POWER PLANT - ENGINE - CLIPPING POINT SUPPORT BRACKET - MODIFICATION OF - CATEGORY
CODE 6 - MOD.ENG-71-0006

V2500-ENG-71-0006

Fig. REMOVAL AND REPLACEMENT OF SUPPORT BRACKET

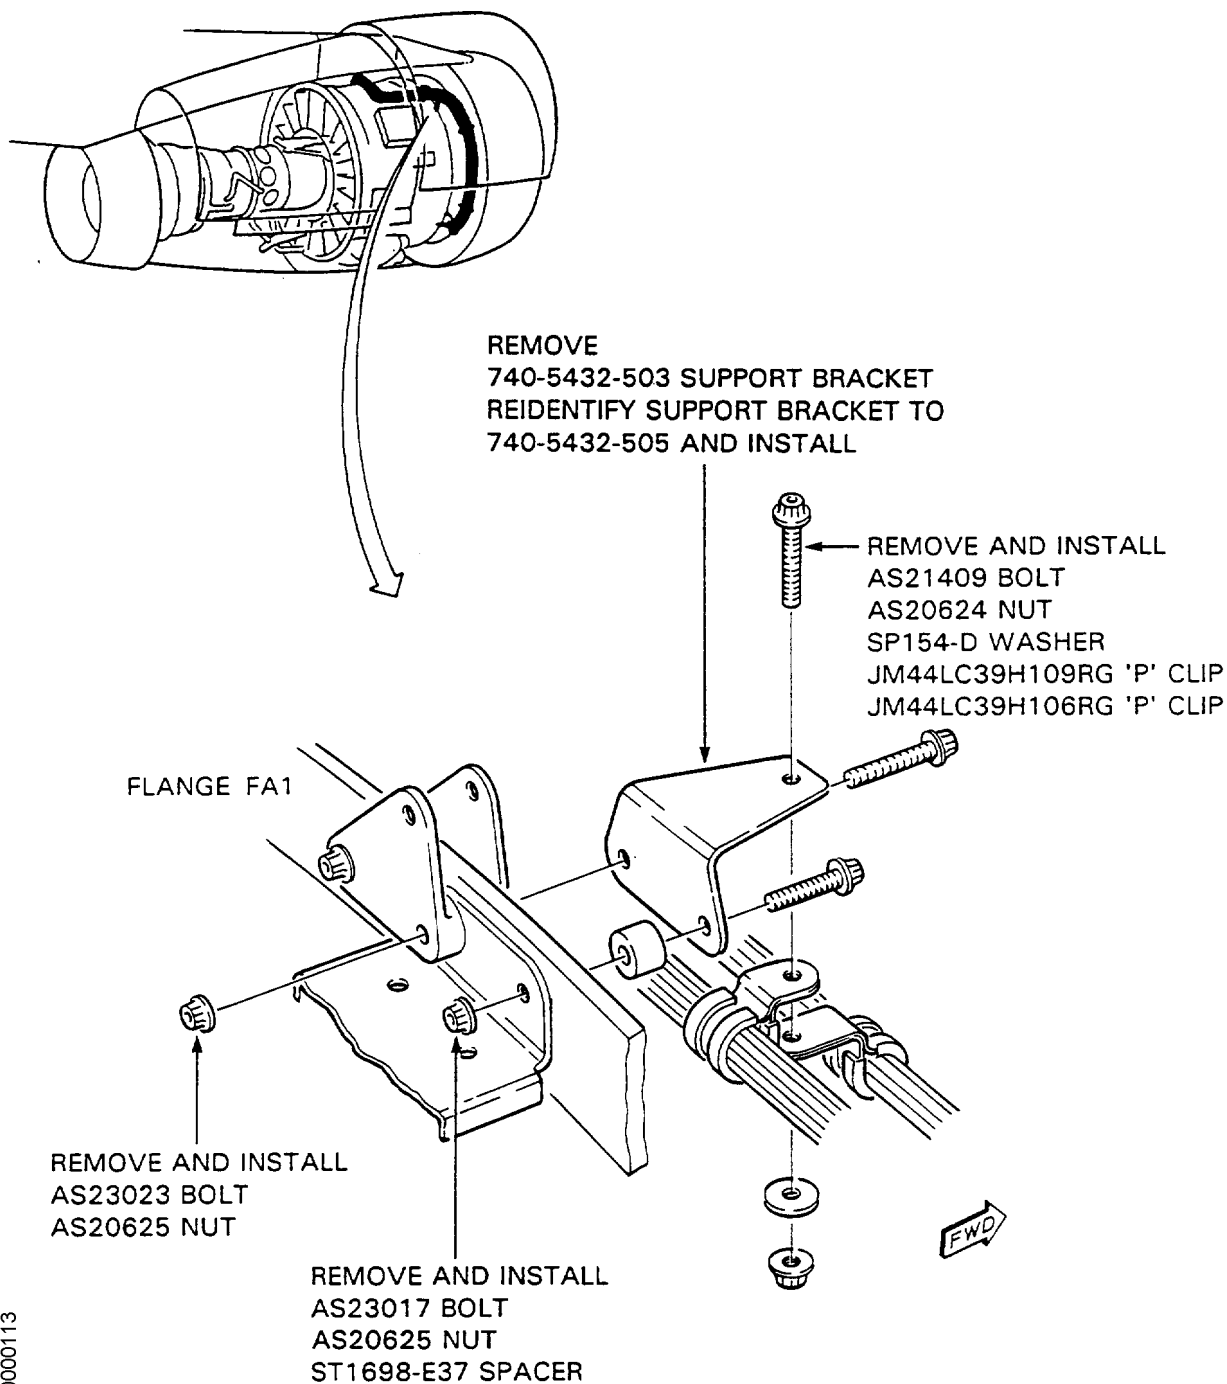
The mounting bolt for the air starter duct support link may touch the support bracket for the fan case clipping point CP0812.

- (1) Find clipping point CP0812 on the right side of the engine fancase (Refer to Figure 1).
- (2) Remove the AS21409 bolt, AS20624 nut and the SP154-D washer to release the JM44LC39H109RG and JM44LC39H106RG 'P' clips (at CP0812).
- (3) Remove the AS23017 bolt, AS20625 nut and an ST1698-E37 spacer as shown.
- (4) Remove the AS23023 bolt and AS20625 nut to release the 740-5432-503 support bracket.

- (1) Install the 740-5432-505 support bracket on the FA1 engine flange with:

- two AS20625 nuts
- AS23017 bolt
- AS23023 bolt
- ST1698-E37 spacer.

Torque the nuts to 100lbf in (1.13 Nm). Refer to the A320 Aircraft Maintenance Manual Section 70-23-11 on torque tightening technique.

- (2) Assemble the clipping point CP0812 to the 740-5432-505 support bracket with:

- AS21409 bolt
- AS20624 nut
- SP154-D washer
- JM44LC39H109RG 'P' clip
- JM44LC39H106RG 'P' clip

Torque the nuts to 40lb in (4.52 Nm).

Fig. MODIFICATION OF THE SUPPORT BRACKET

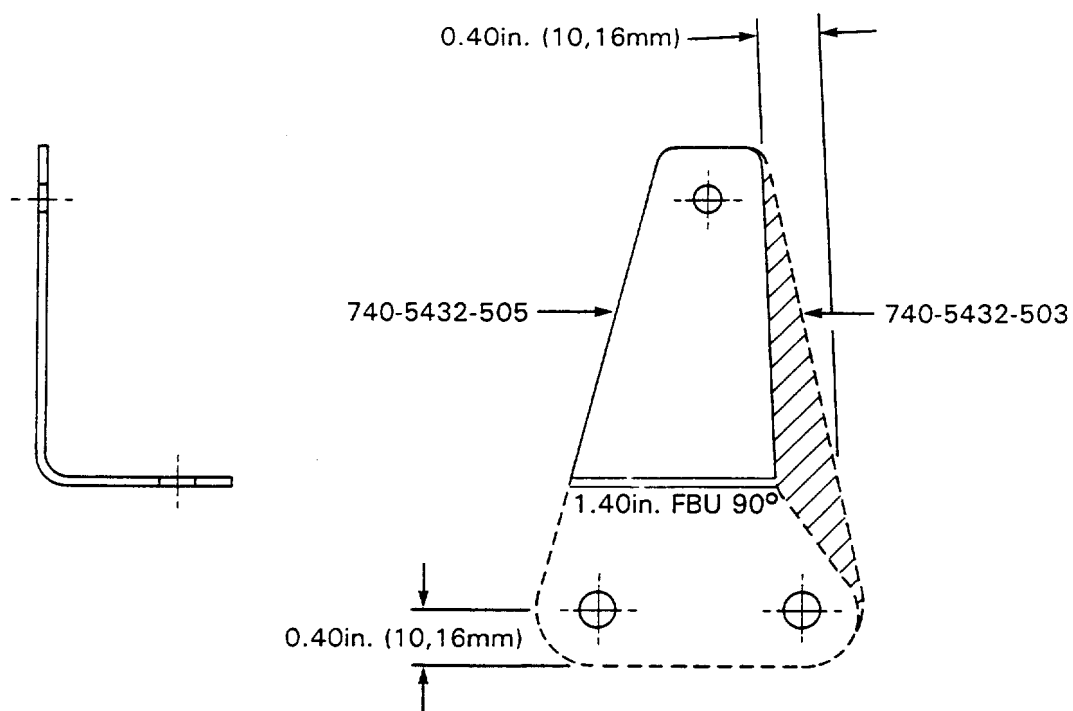
- (a) The support bracket for clipping point CP0812 is temporarily removed. The bracket is modified and the part number is changed (Refer to Illustration 2). The bracket is then re-installed back onto the engine and the clipping point reassembled.

NOTE: Remove the hatched part on the support bracket and identify to new part number (740-5432-505)

Procedure	Supplementary Information
(a) Cut off that part of the support bracket that is shown hatched.	Refer to Figure 2
(b) Remove any sharp corners or burrs.	
(c) Identify the bracket to the new part number with No. 127 1/2 Master Marker (or any alternative marking ink).	740-5432-505
